ROYAL CANADIAN AIR FORCE

EO 05-45B-2U 13 Oct 61

DESCRIPTION AND MAINTENANCE INSTRUCTIONS

CABIN COLD AIR INTAKE PLUGS

Figure 1

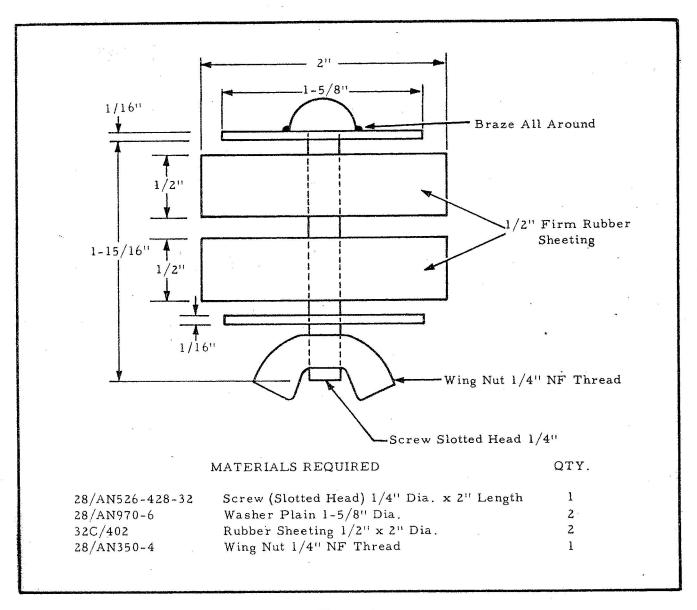
In order to improve the heating system in Expeditor Aircraft, units may manufacture, from unit sources blanking plugs as per Figure 1 and install in the cabin cold air intakes as required.

- 2 Carry out the following instructions:
- (a) Braze slotted head screw 28/AN526-428-32 to washer 28/AN970-6.
- (b) Cut 2 each 2 inches OD rubber washers from 326/402 rubber sheeting 1/2 inch thick.
- (c) Assemble as per Figure 1.
